NORTH ANNA POWER STATION

Section 3.4
Reactor Coolant System (RCS)
Book 2

VOLUME 12
Improved Technical Specifications

SECTION 3.4 - REACTOR COOLANT SYSTEM (RCS)

Figure 3.4.3-1

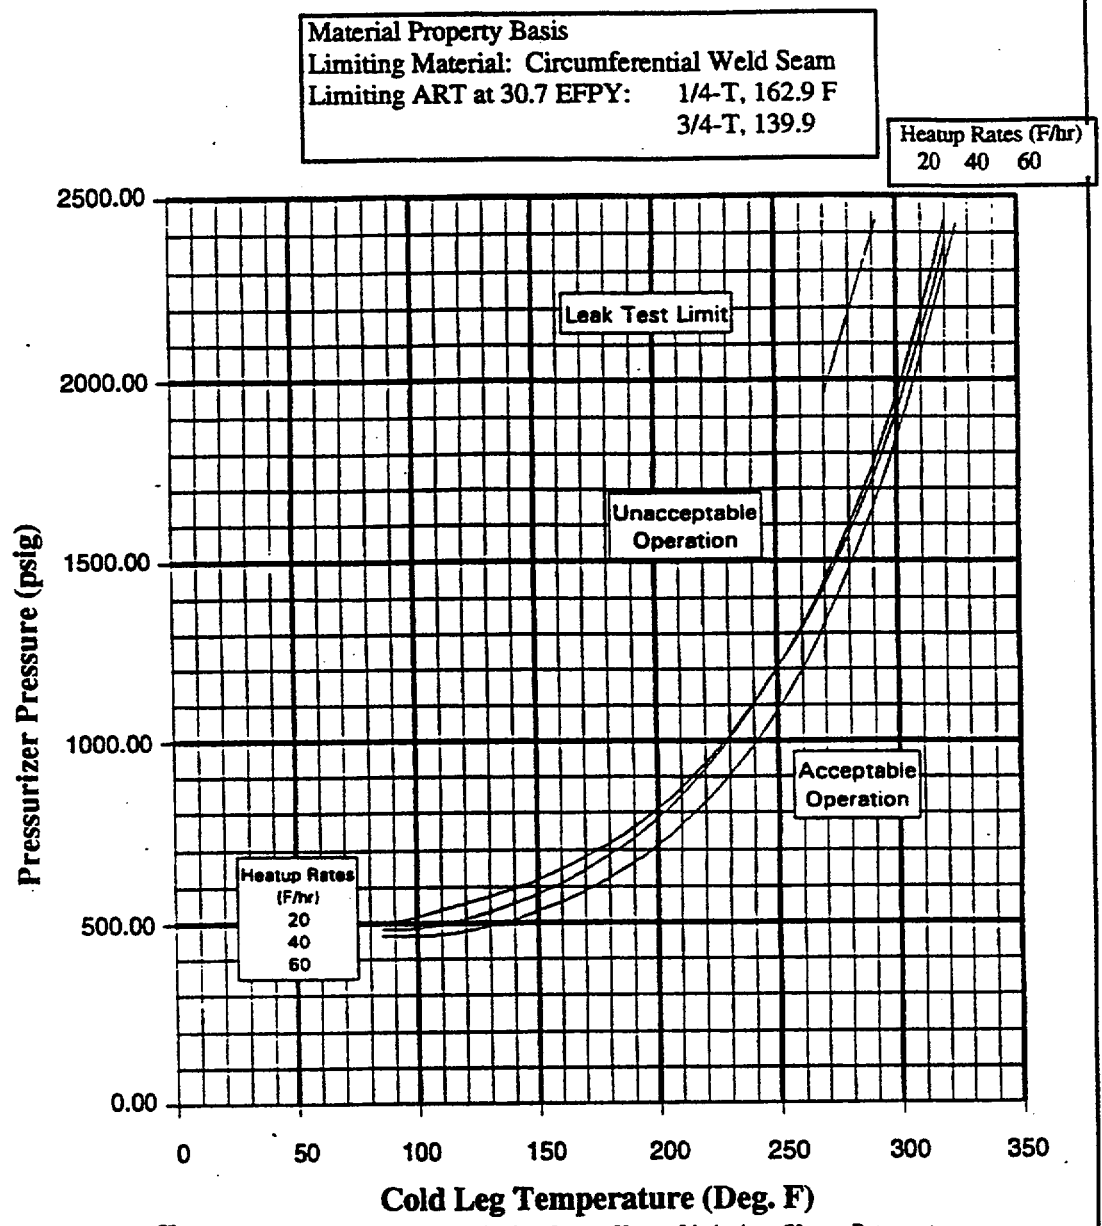
Figure 3.4-2 — North Anna Unit 1
Reactor Coolant System Heatup Limitations

Figure 3.4-3 — North Anna Unit 1
Reactor Coolant System Cooldown Limitations

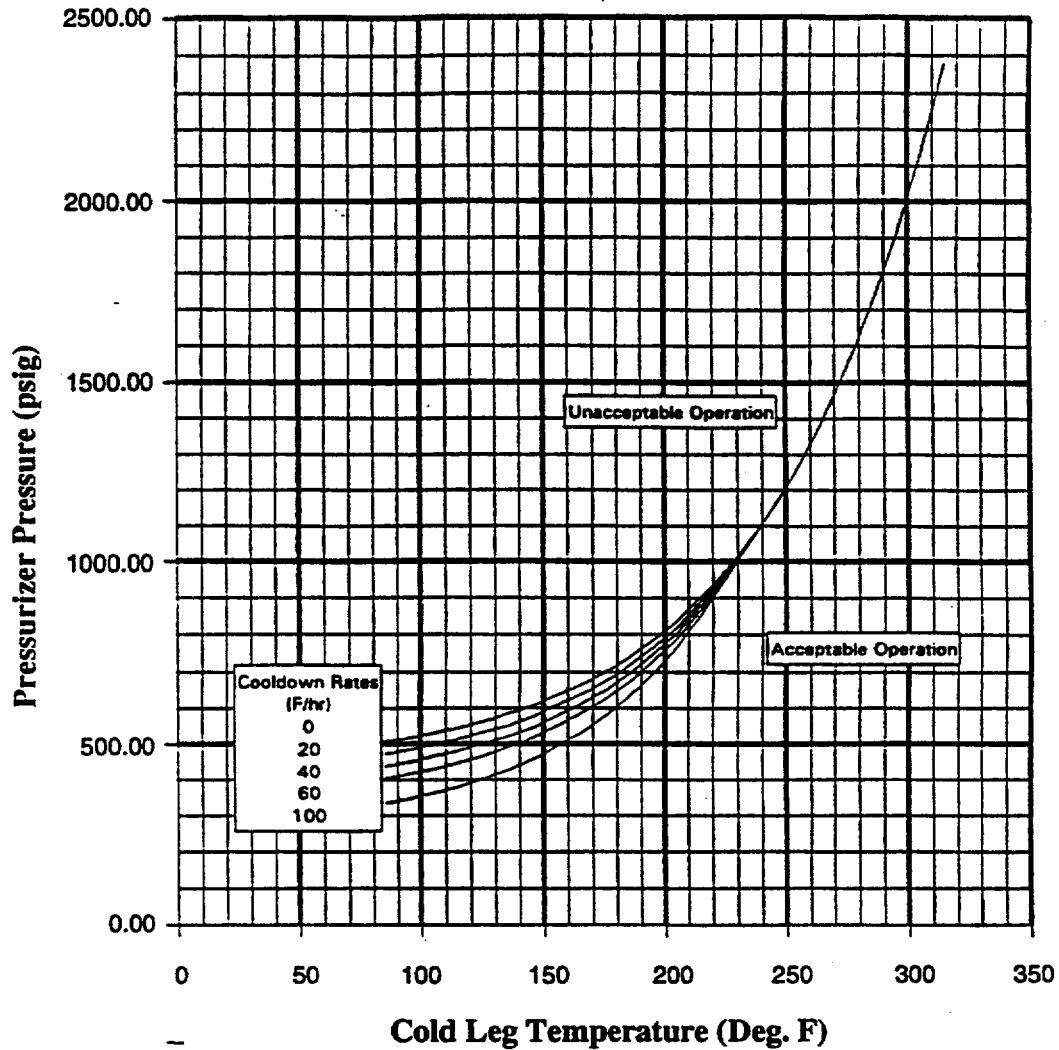
Limiting Material: Circumferential Weld Seam

Limiting ART at 30.7 EFPY: 1/4-T, 162.9 F

3/4-T, 139.9 F

Figure
3.4.3-3

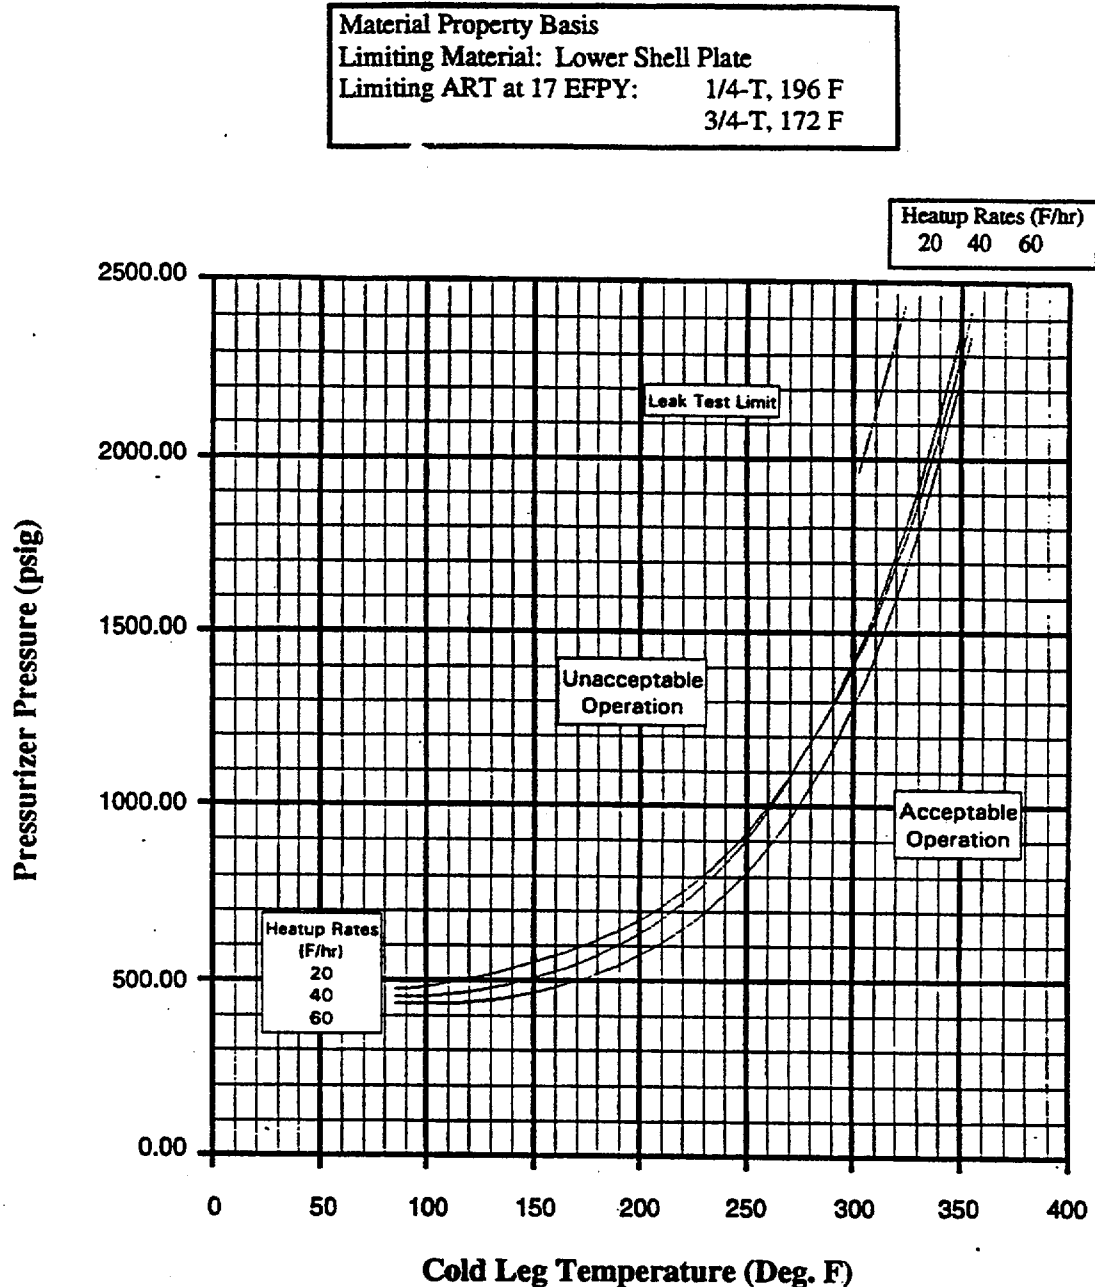
Figure 3.4-2 — North Anna Unit 2
Reactor Coolant System Heatup Limitations

Figure 3.4-3 — North Anna Unit 2
Reactor Coolant System Cooldown Limitations

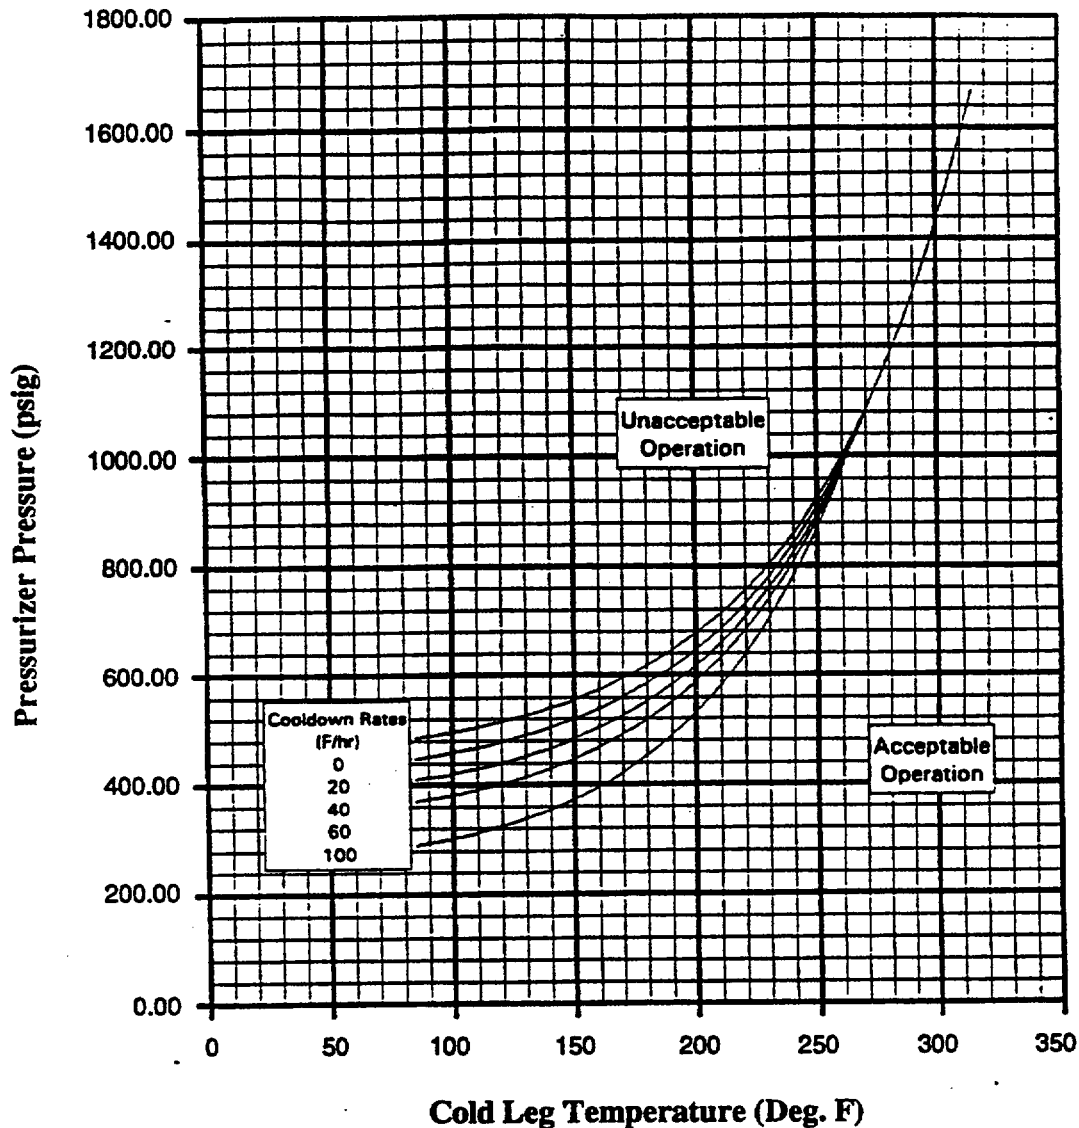
Material Property Basis
Limiting Material: Lower Shell Plate
Limiting ART at 17 EFPY: 1/4-T, 196 F
3/4-T, 172 F

Figure
3.4.16-1

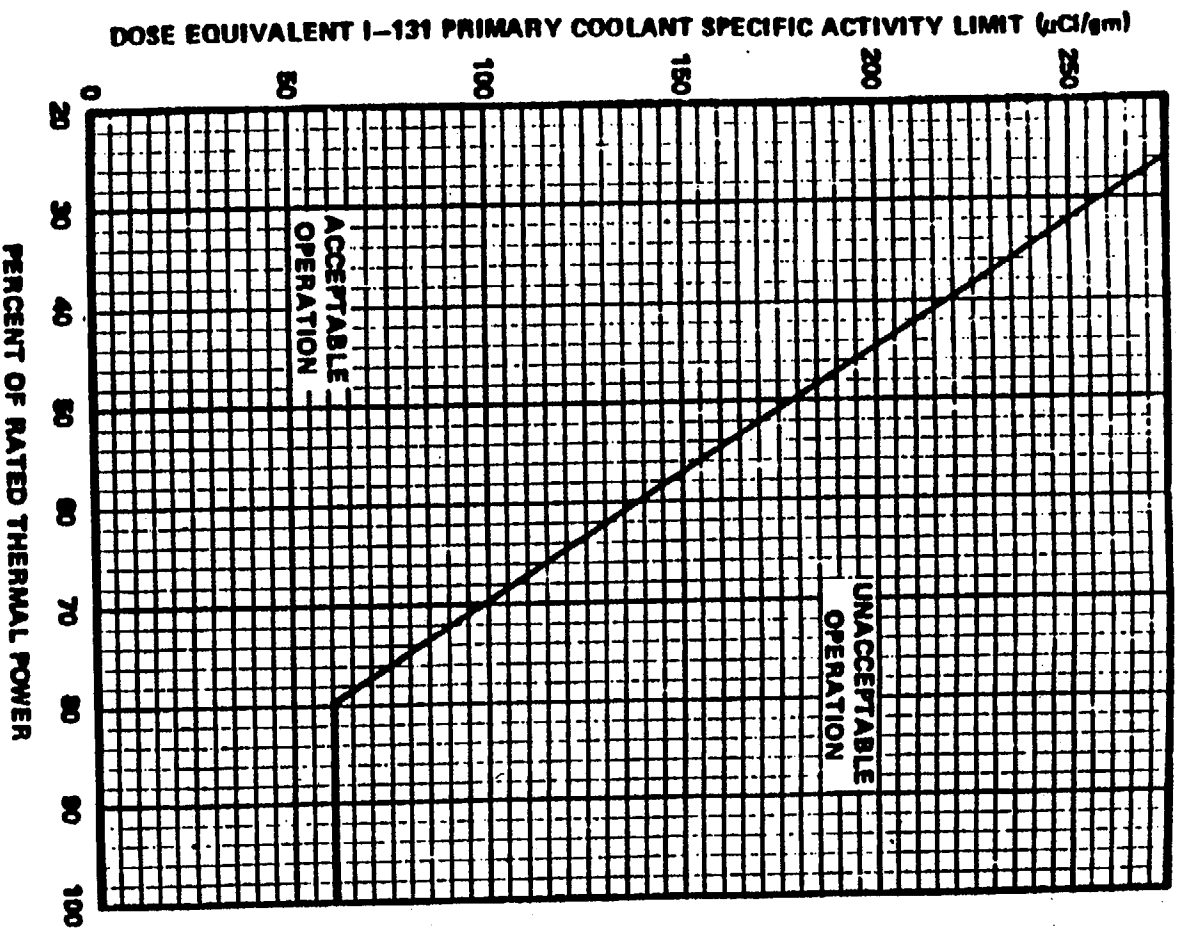
- a. With the specific activity of the primary coolant $> 1.0 \mu\text{Ci/gram DOSE EQUIVALENT I-131}$ for more than 48 hours during one continuous time interval or exceeding the limit line shown on Figure 3.4-1, be in at least HOT STANDBY with $T_{\text{avg}} < 500^\circ\text{F}$ within 6 hours.
- b. With the specific activity of the primary coolant $> 100/E \mu\text{Ci/gram}$, be in at least HOT STANDBY with $T_{\text{avg}} < 500^\circ\text{F}$ within 6 hours.

Figure
3.4.16-1

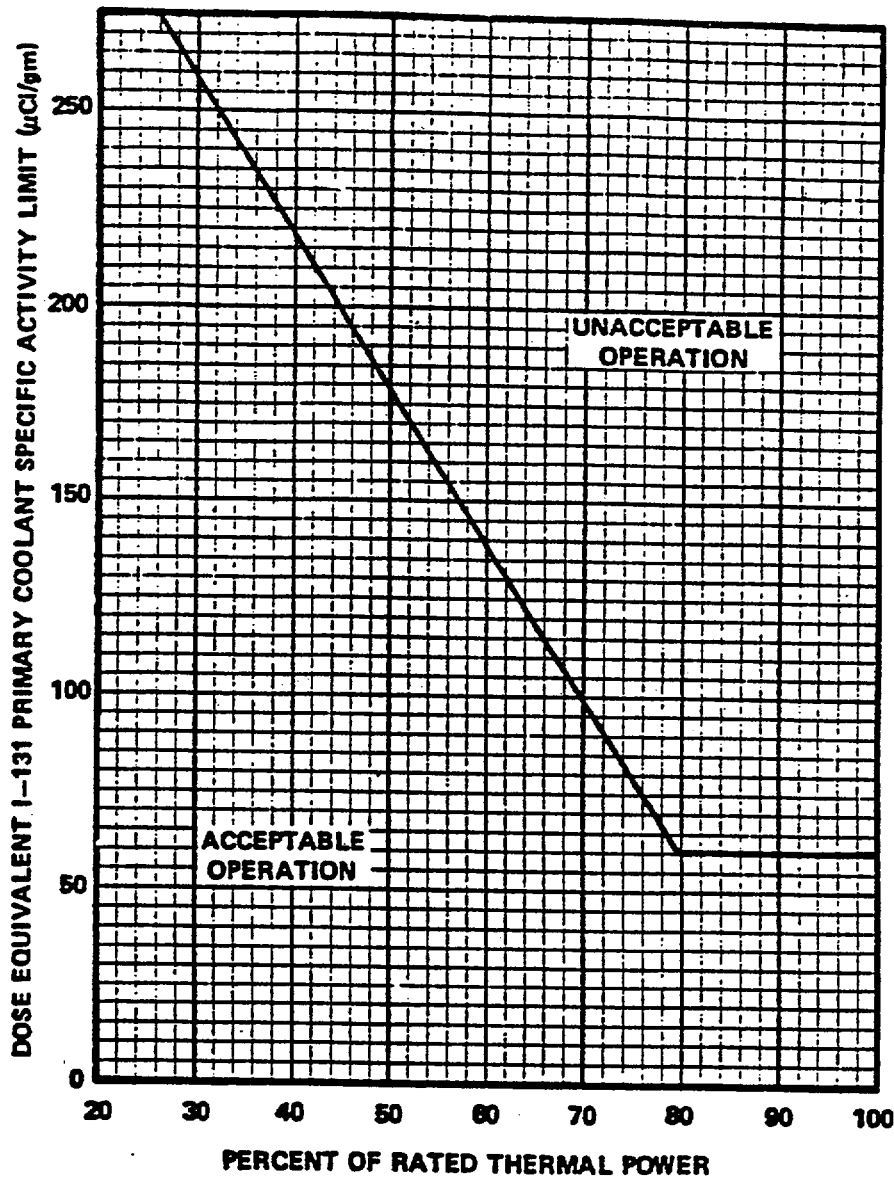
- (L.1)
- a. With the specific activity of the primary coolant greater than 1.0 $\mu\text{Ci}/\text{gram}$ DOSE EQUIVALENT I-131 for more than 48 hours during one continuous time interval or exceeding the limit line shown on Figure 3.4-1, be in at least HOT STANDBY with T_{avg} less than 500°F within 6 hours.
 - b. With the specific activity of the primary coolant greater than $100/\bar{E}$ $\mu\text{Ci}/\text{gram}$, be in at least HOT STANDBY with T_{avg} less than 500°F within 6 hours.

- L.2 (*Category 4 – Relaxation of Required Action*) CTS 3.4.8, Action a., states that when the specific activity of the primary coolant $> 1.0 \mu\text{Ci}/\text{gram}$ DOSE EQUIVALENT I-131 for more than 48 hours during one continuous time interval or exceeding the limit line shown on Figure 3.4-1, be in at least HOT STANDBY with $T_{\text{avg}} < 500^\circ\text{F}$ within 6 hours. ITS 3.4.16, Action A states that with DOSE EQUIVALENT I-131 $> 1.0 \mu\text{Ci}/\text{gm}$, restore the DOSE EQUIVALENT I-131 to within limit within 48 hours. ITS 3.4.16, Action C, states that if the Required Actions and associated Completion Times of Action A are not met, be in MODE 3 with $T_{\text{avg}} < 500^\circ\text{F}$ within 6 hours. ITS 3.4.16, Action A, is modified by a Note which states that LCO 3.0.4 is not applicable. This changes the CTS by allowing MODE changes, currently prohibited by LCO 3.0.4, while relying on ITS Action A.
